*LEOMINSTER*  
*LOCAL PROTECTION PROJECT*

**MONOOSNOC BROOK**  
**LEOMINSTER, MASSACHUSETTS**

*FINAL*  
*ENVIRONMENTAL STATEMENT*  
*& 404 EVALUATION*

JANUARY 1980

Figure 4

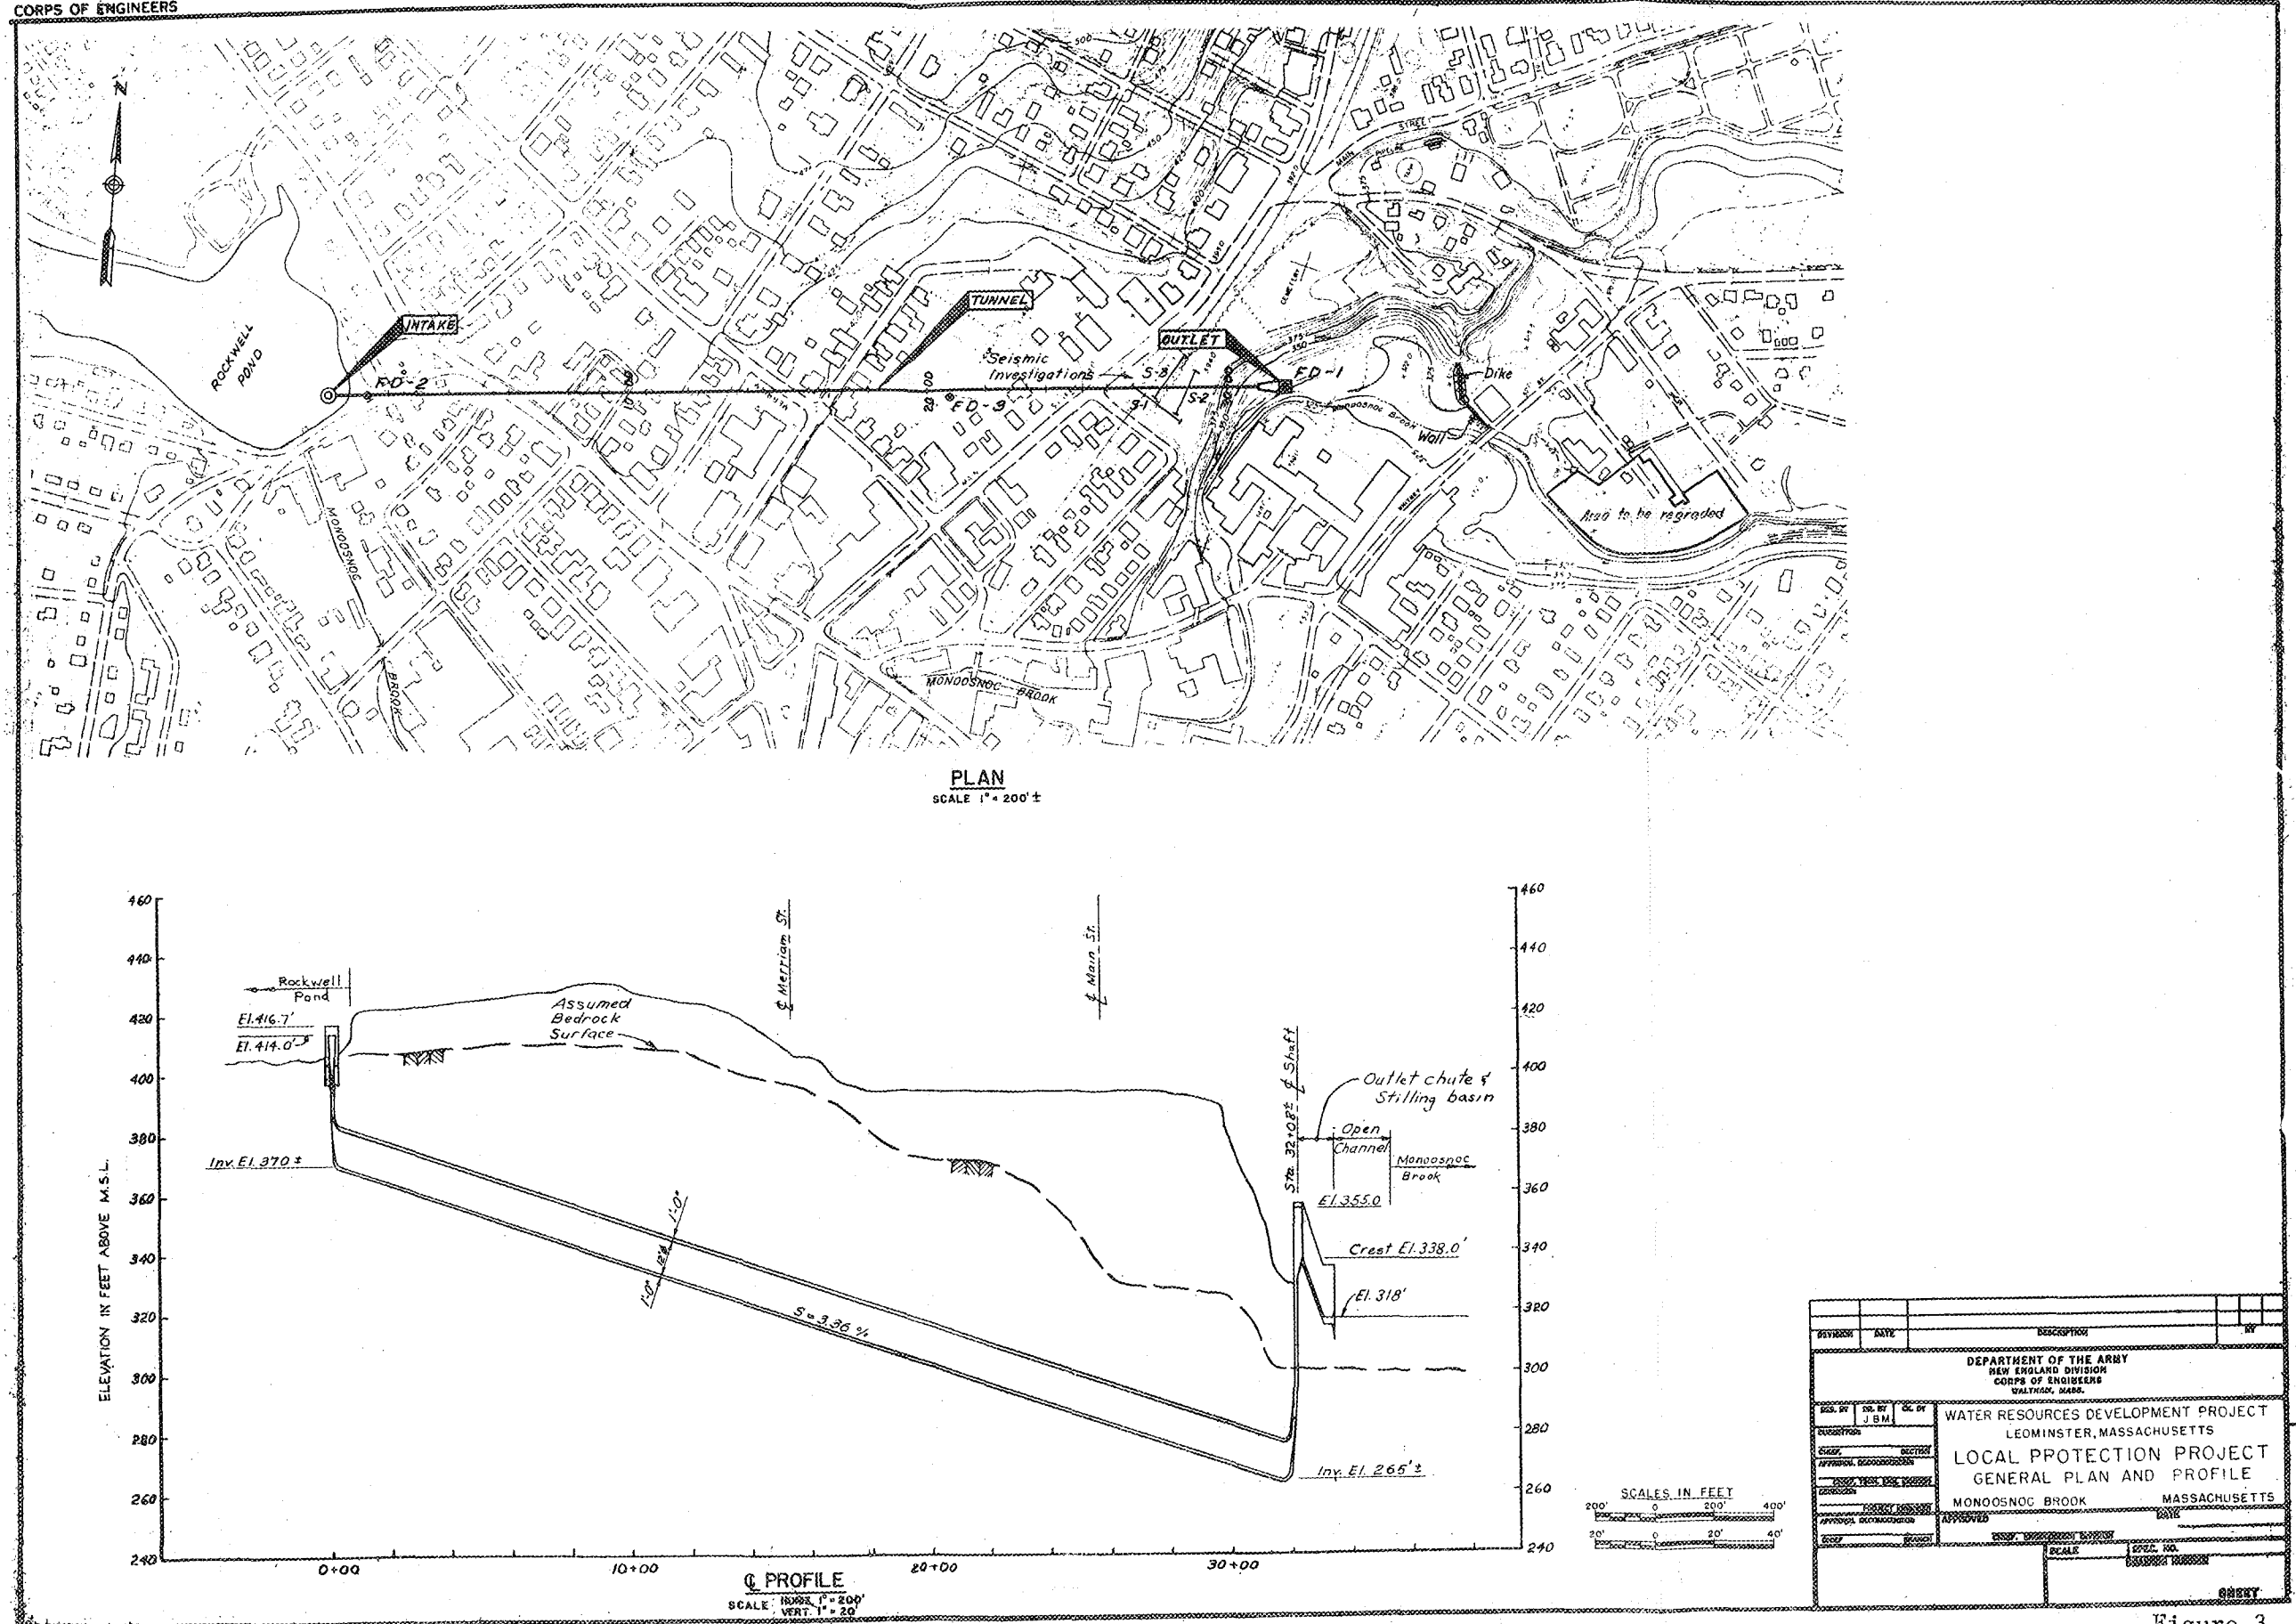
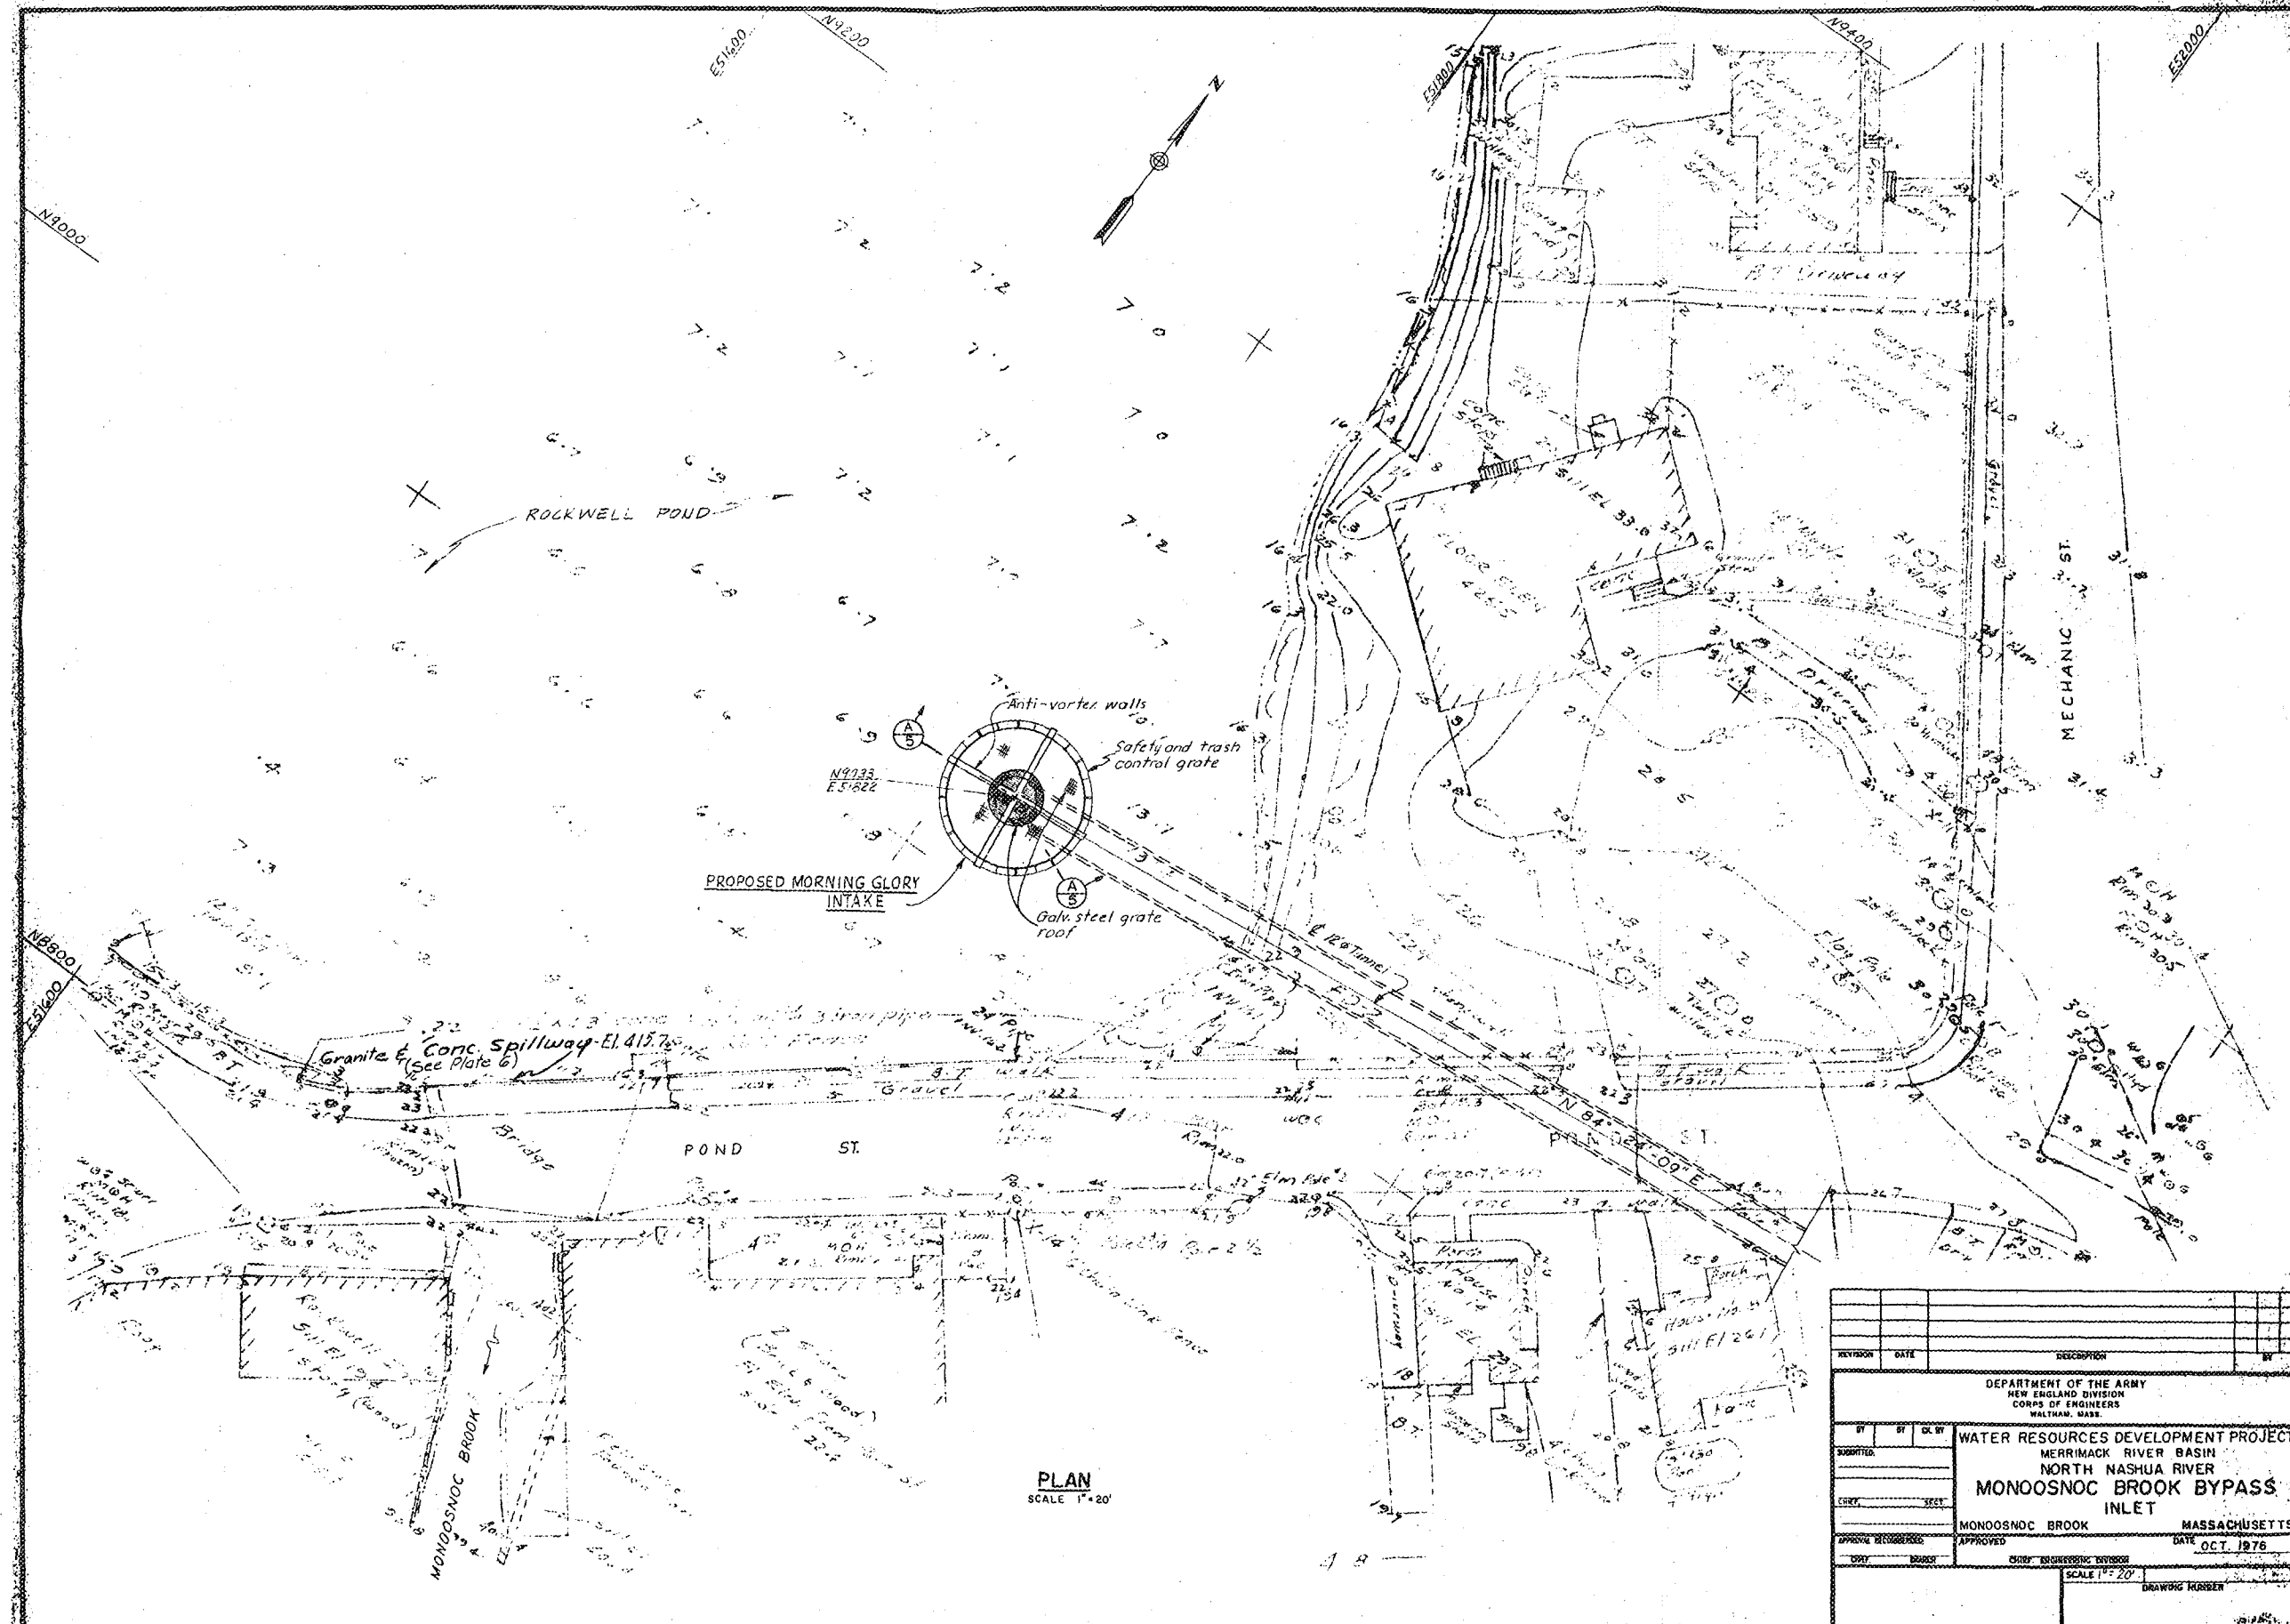
Comment: "1:13 - No mention made of how debris, pollutants, etc., will be restricted from entering the pipe system, and who will be responsible for its maintenance."

Response: The cap over the intake structure and the grating around the cap will prevent most larger debris from entering the tunnel. (This information can be found on page 1-3 and on Figure 4 of the EIS.) However, some debris and dissolved materials will enter the tunnel, but the force of the water should drive most of it out. Thus, the water remaining in the tunnel after floodwaters have subsided should be fairly free of these materials.

Figure 5A

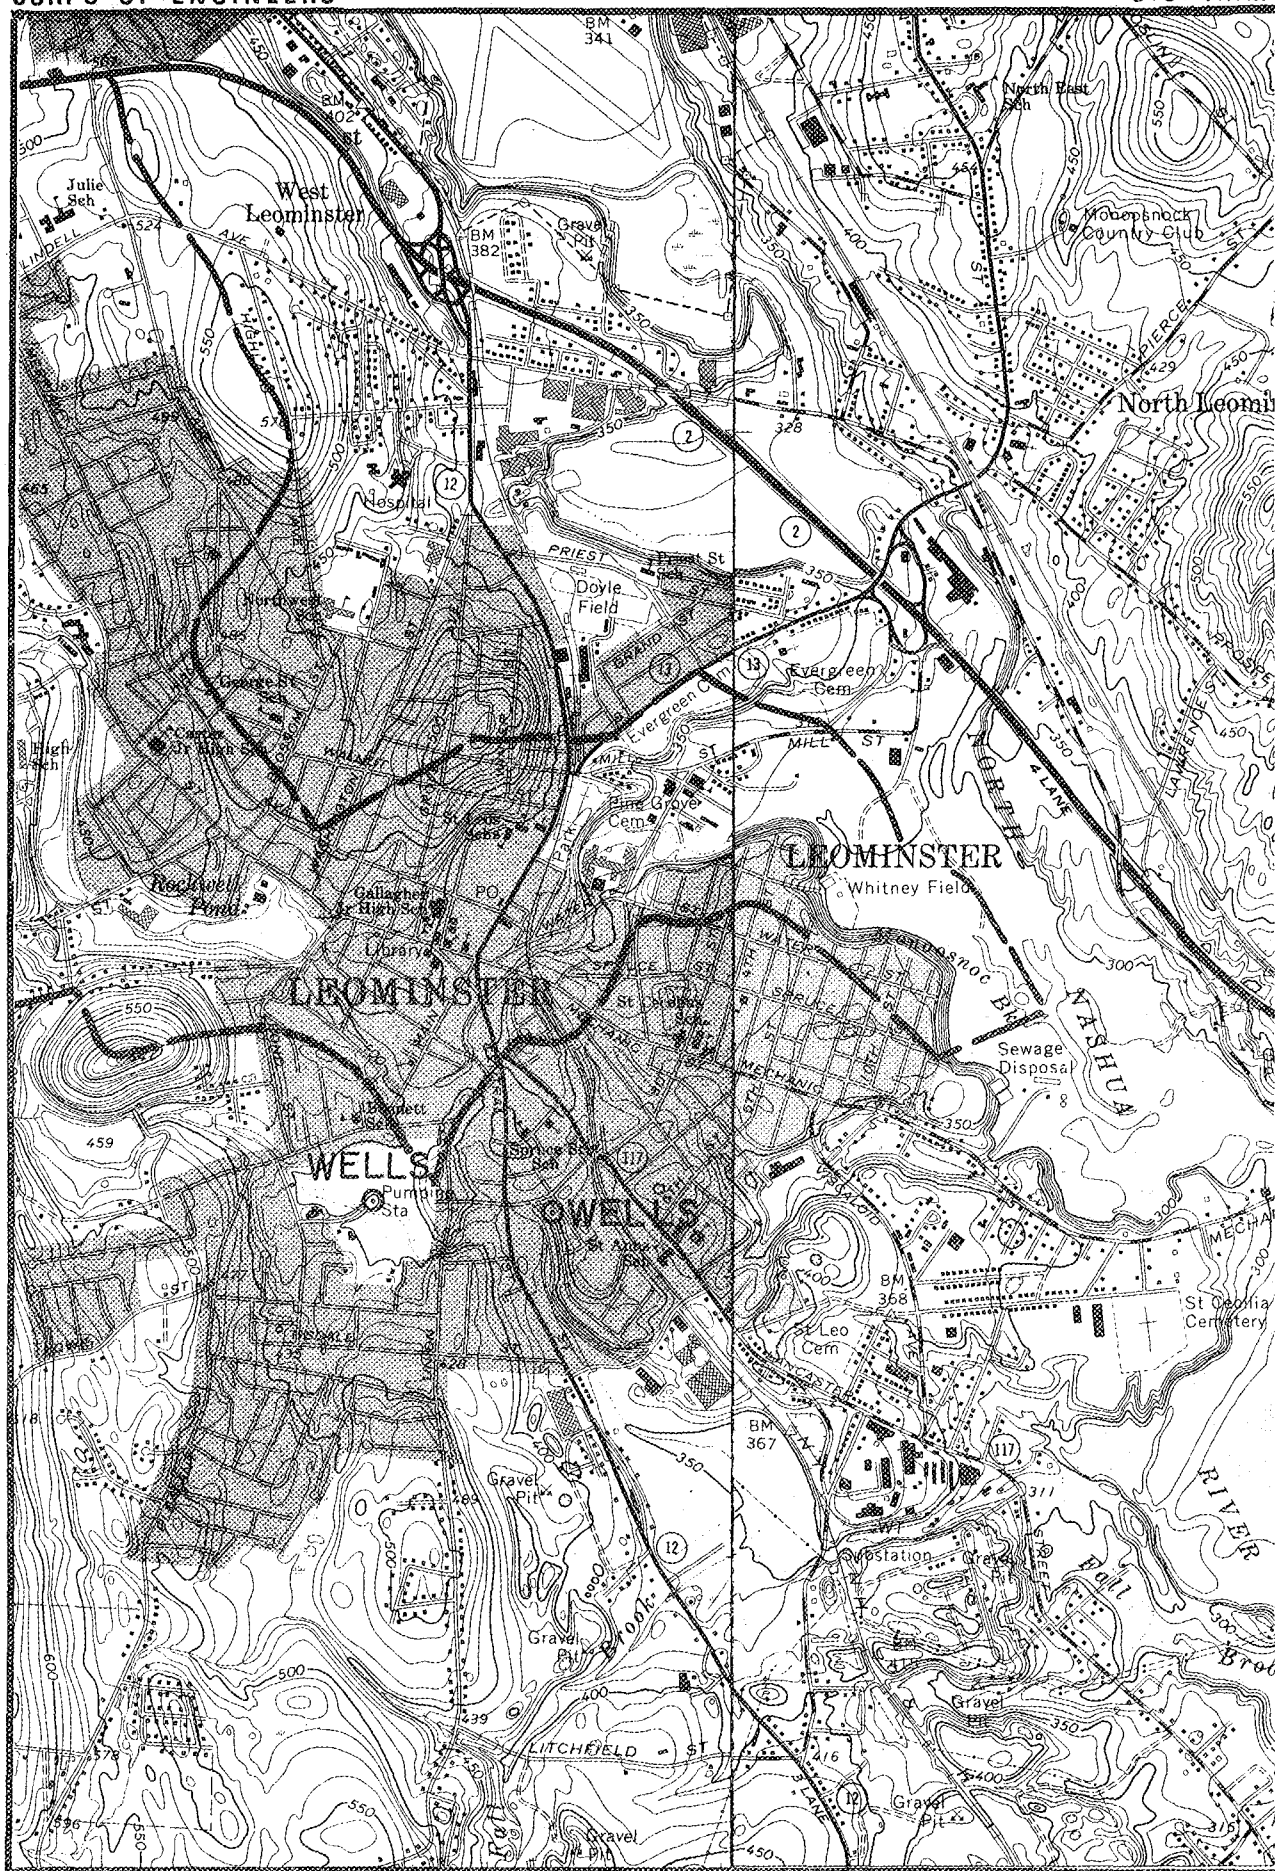
Comment: "It would be useful if the statement would show the location of the wells used to supply the city in relation to the alignment of the tunnel. The aquifer(s) tapped by the wells should be indicated, especially if they penetrate bedrock. If the wells are in the vicinity of the tunnel site, evaluation of the potential for seepage from the tunnel, and/or perhaps the degree of treatment of the ground water would be appropriate."

Response: When the Corps first learned of the wells, there was concern that the tunnel might affect the wells' aquifers. However, when it was learned that the wells are in a different drainage system and that the Monoosnoc Brook is separate from the tunnel and the wells, it was decided that there would be little possibility of the tunnel affecting the aquifers. Figure 5A has been included in the EIS to display this point.
